## STAFF REPORT

SUBJECT: FP-2021-0043  
Pura Vida Ridge Ranch No. 1

Final plat consisting of 58 buildable lots and 13 common lots on 7.63-acres of land in the R-15 zoning district for the first phase of Pura Vida Ridge Ranch Subdivision.

# B. Final Plat (date: 7/30/2021)

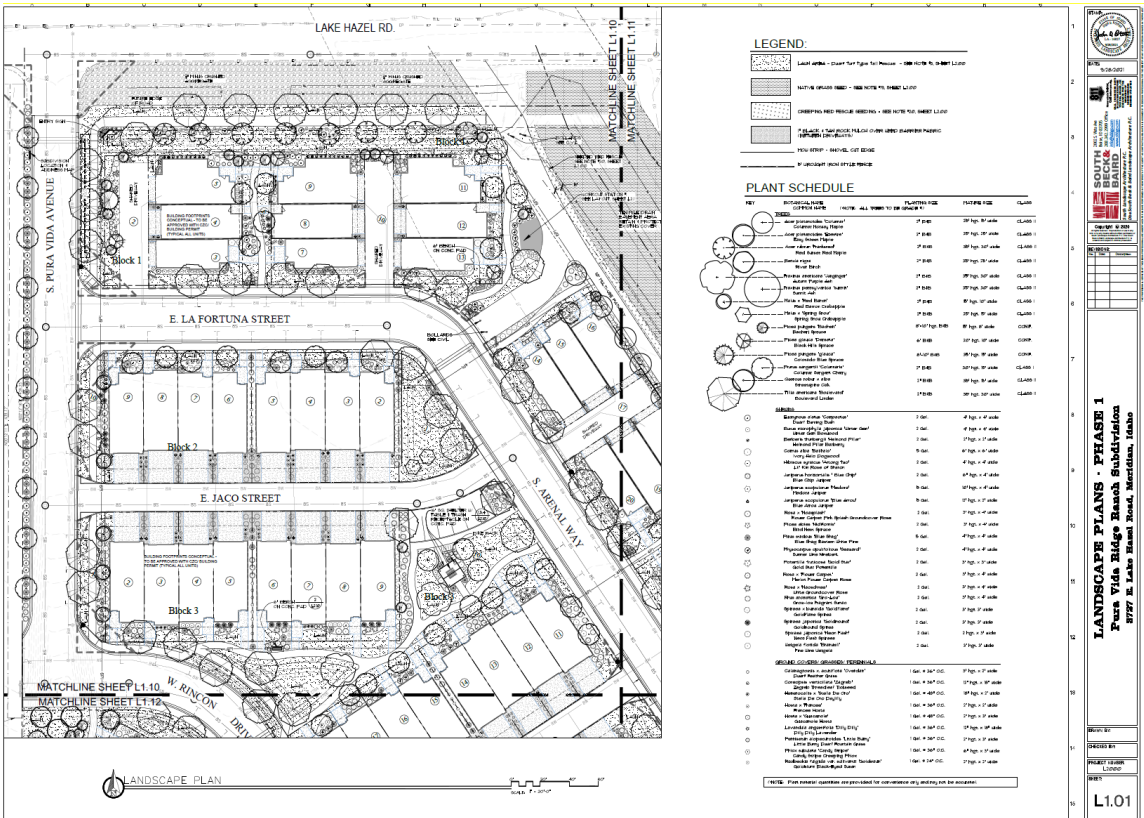
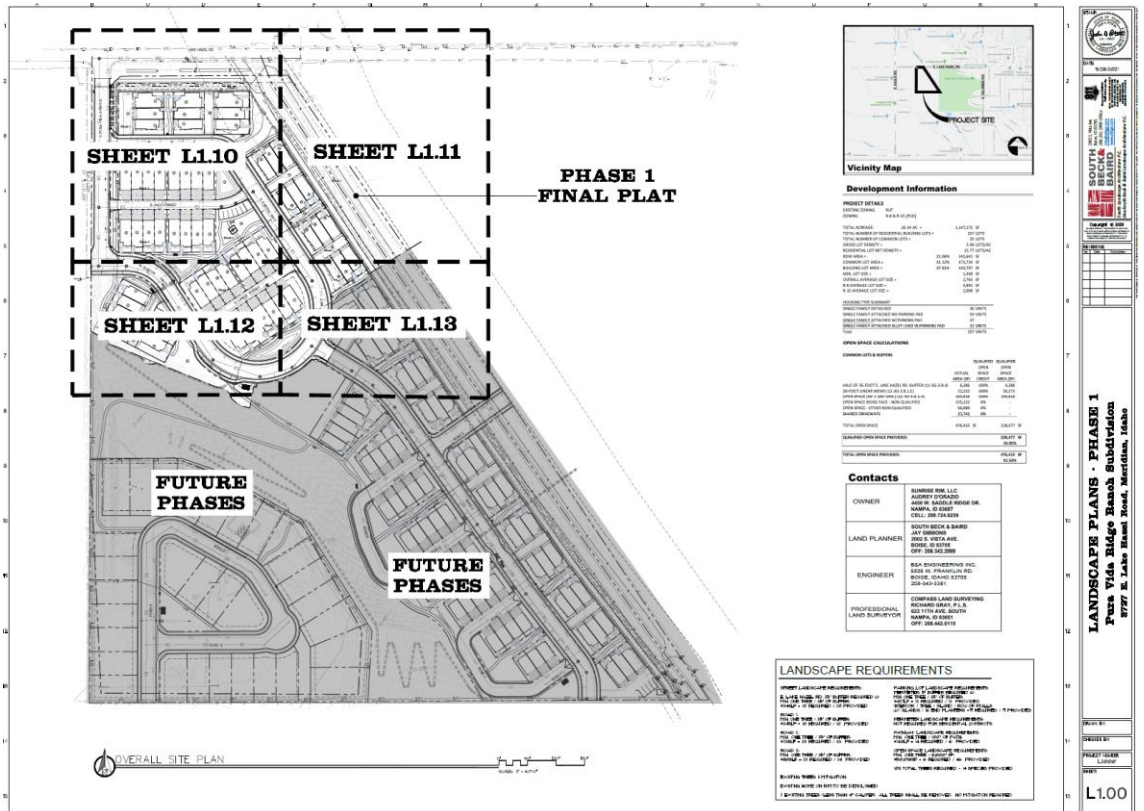
1. Applicant shall comply with all previous conditions of approval associated with this development (H-2020-0064, Development Agreement Inst. #2021-042520).
2. The applicant shall obtain the City Engineer's signature on the final plat within two (2) years of City Council's approval of the preliminary plat (by January 19, 2023) in accord with UDC 11-6B-7 in order for the preliminary plat to remain valid; or, a time extension may be requested.
3. Prior to submittal for the City Engineer's signature, have the Certificate of Owners and the accompanying acknowledgement signed and notarized.
4. The final plat shown in Section V.B prepared by B & A Engineers, Inc., stamped on 7/30/2021 by Joseph D. Canning, shall be revised as follows:

- a. Include recorded instrument number of existing storm drainage maintenance easement.

- b. Note #6: ". . . in compliance with ~~H-2019-0058~~ H-2020-0064."
- c. Note #9: ". . . prior approval from the health authority and the City of Meridian."
- d. Note #16: Include date and recorded instrument numbers for the ACHD storm water drainage system.

- e. The minimum property size in the R-15 zoning district is 2,000 square feet per UDC Table 11-2A-7; revise Lots 4, 8, 12, 15, 16, 18, 19, 23, 24, 26, and 27, Block 1 and Lots 2, 3 and 7, Block 5 to comply.
- f. Correct the number of buildable/open space lots in the Purpose of the Survey Narrative.
- g. Include a curve reference # for the south end of Lot 10, Block 1.

***An electronic copy of the revised plat shall be submitted to the Planning Division prior to signature on the final plat by the City Engineer.***

C. Landscape Plan (date: 9/28/2021)

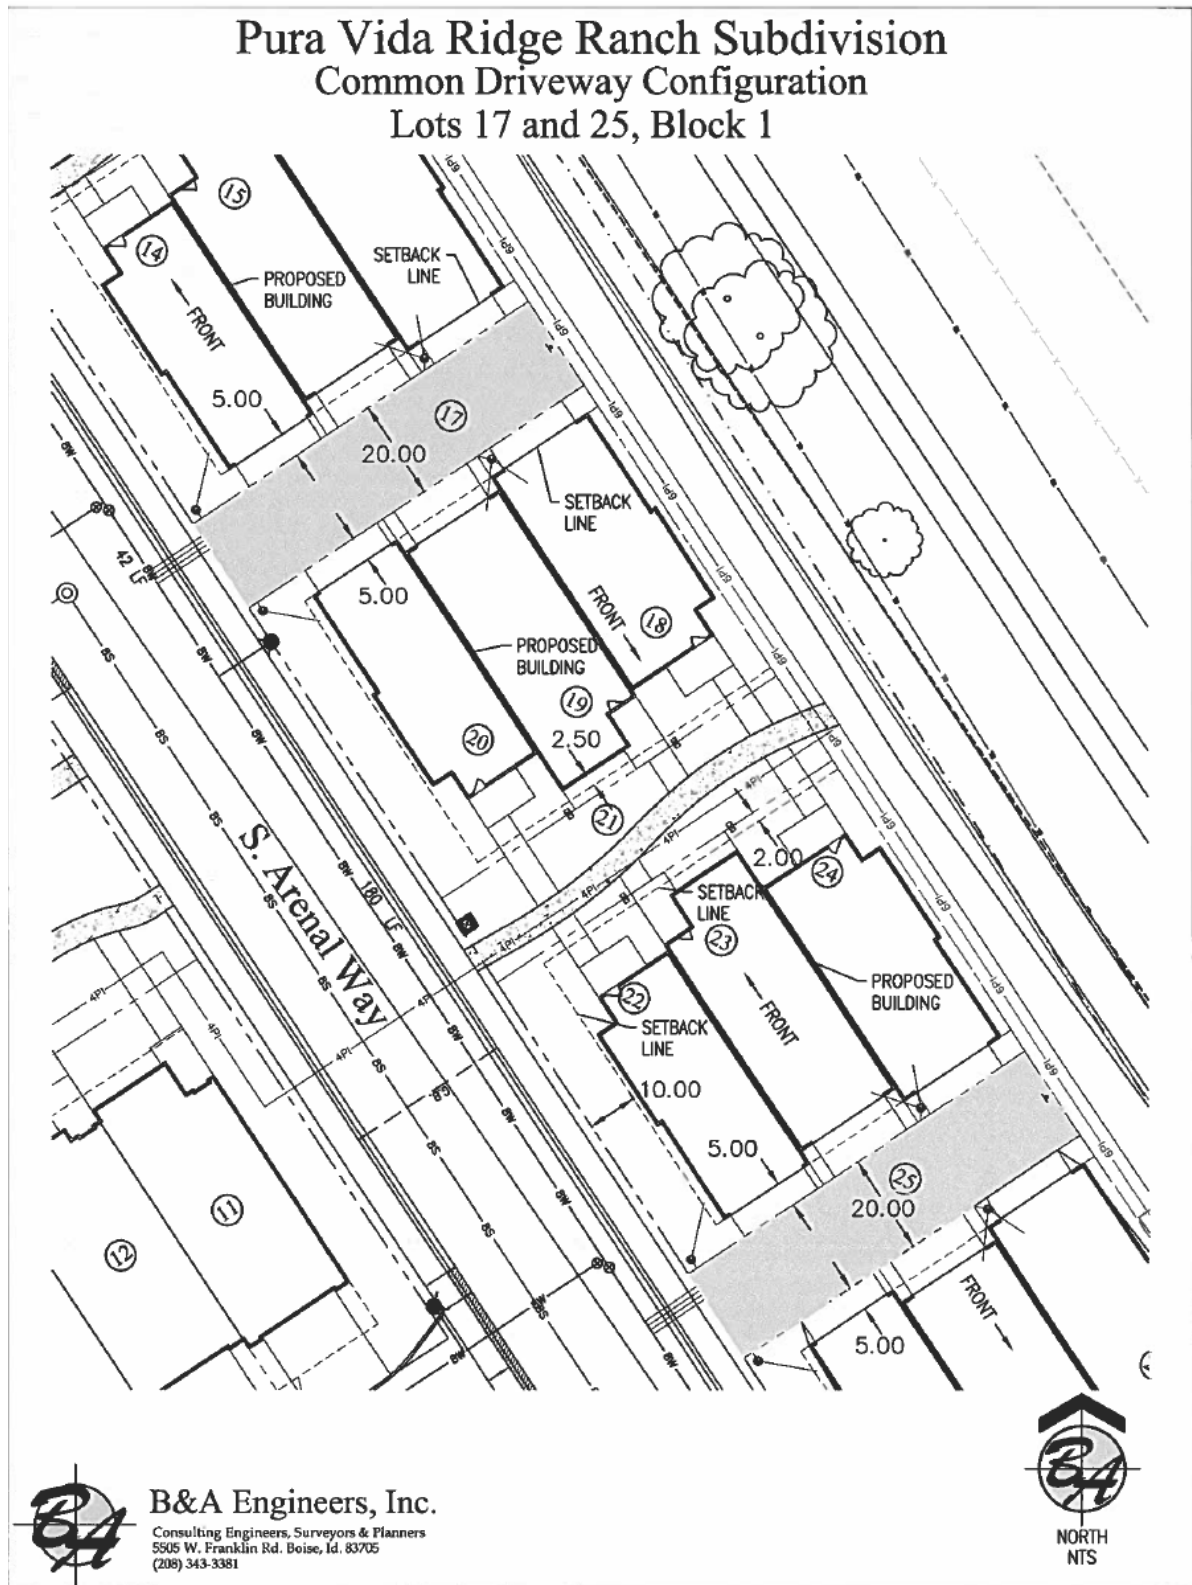
5. The landscape plan shown in Section V.C, prepared by South Beck & Baird, dated 9/28/21, shall be revised as follows:
  - a. The pathway encroaches on the corner of Lot 13, Block 1; relocate the pathway outside of the buildable lot.
  - b. Depict fencing abutting pathways and common open space lots to distinguish common from private areas per the standards listed in UDC 11-3A-7A.7; include a detail(s) of the proposed fence. *Note: This section of Code is eligible for alternative compliance.*

***An electronic copy of the revised landscape plan shall be submitted to the Planning Division prior to signature on the final plat by the City Engineer.***

D. Common Driveway Exhibits

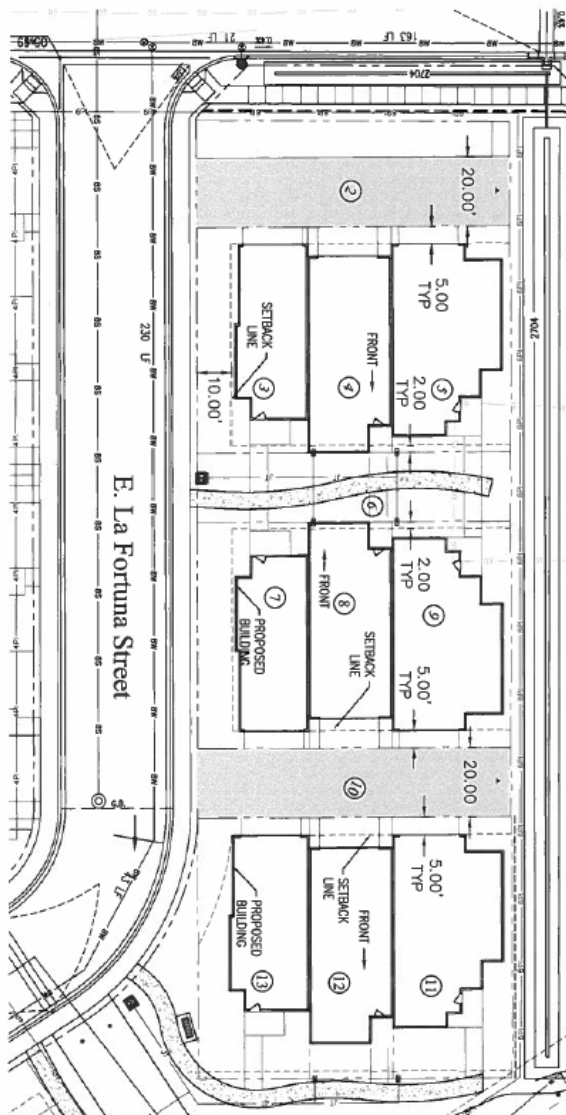
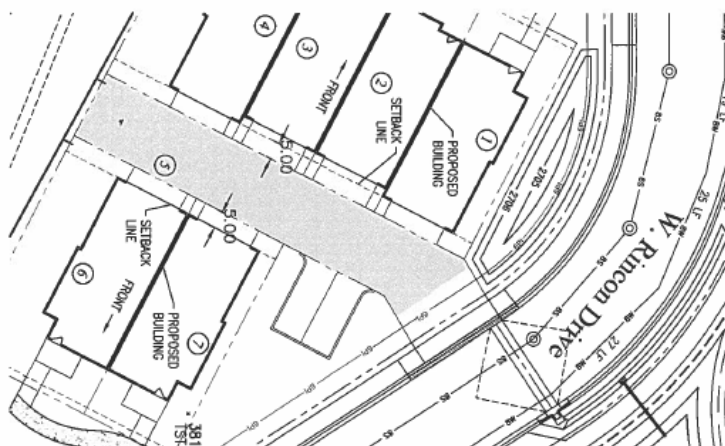
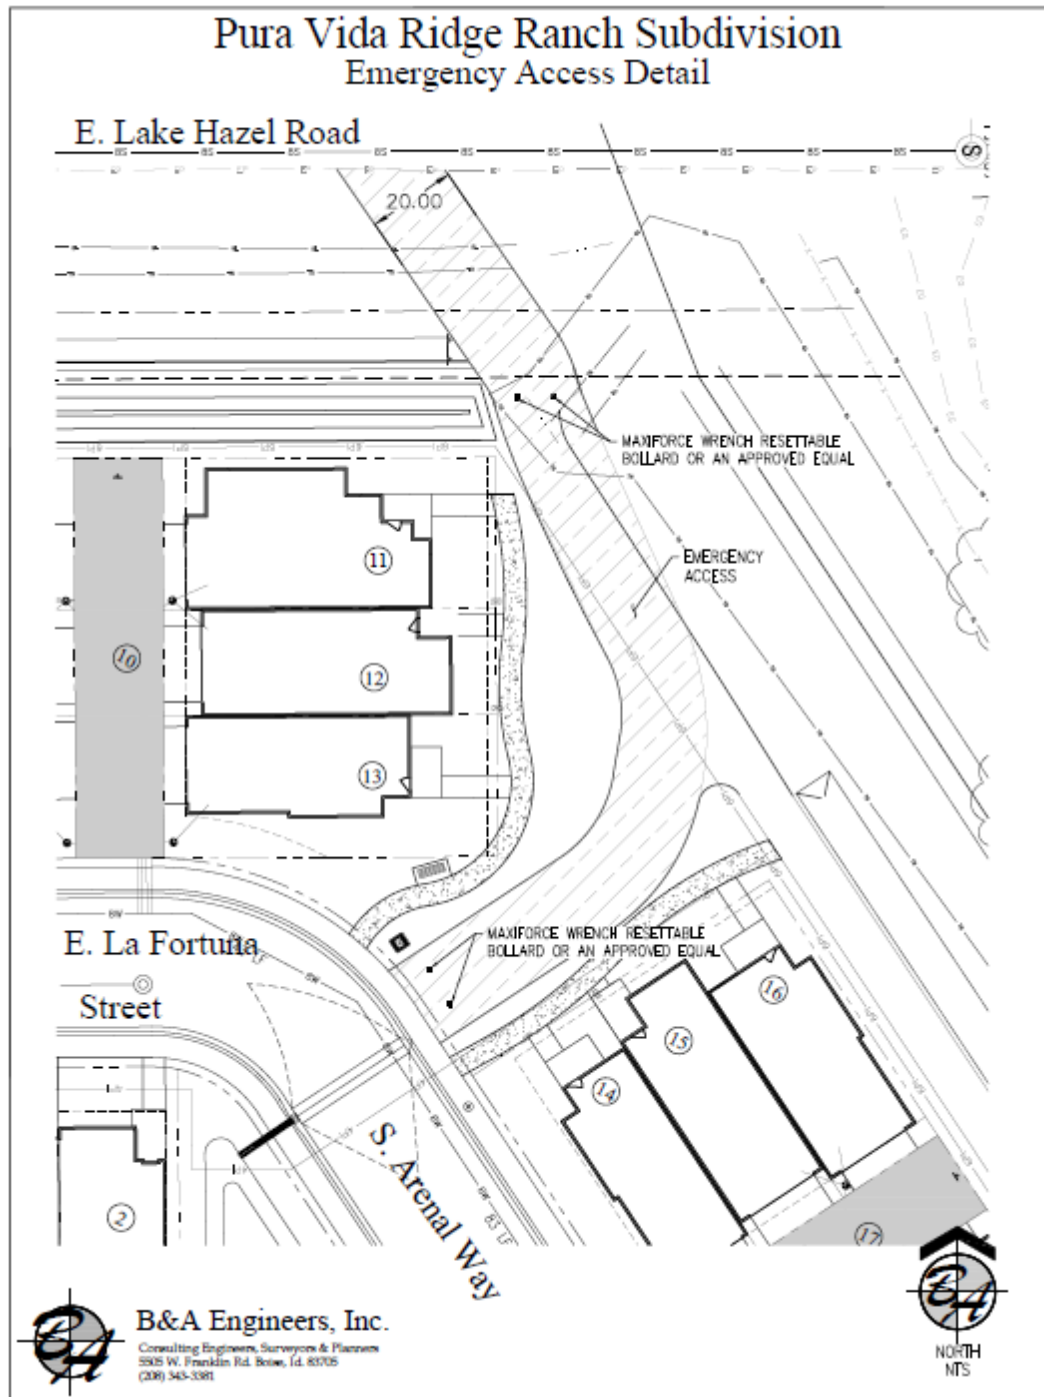
7. Development of Lots 3-5, 7-9, 11-13, 14-16, 18-20, 22-24 and 26-28, Block 1 and Lots 1-4 and 7-8, Block 5 shall comply with the setbacks depicts on the common driveway exhibits in Section V.D and as approved with the Planned Unit Development (H-2020-0064).
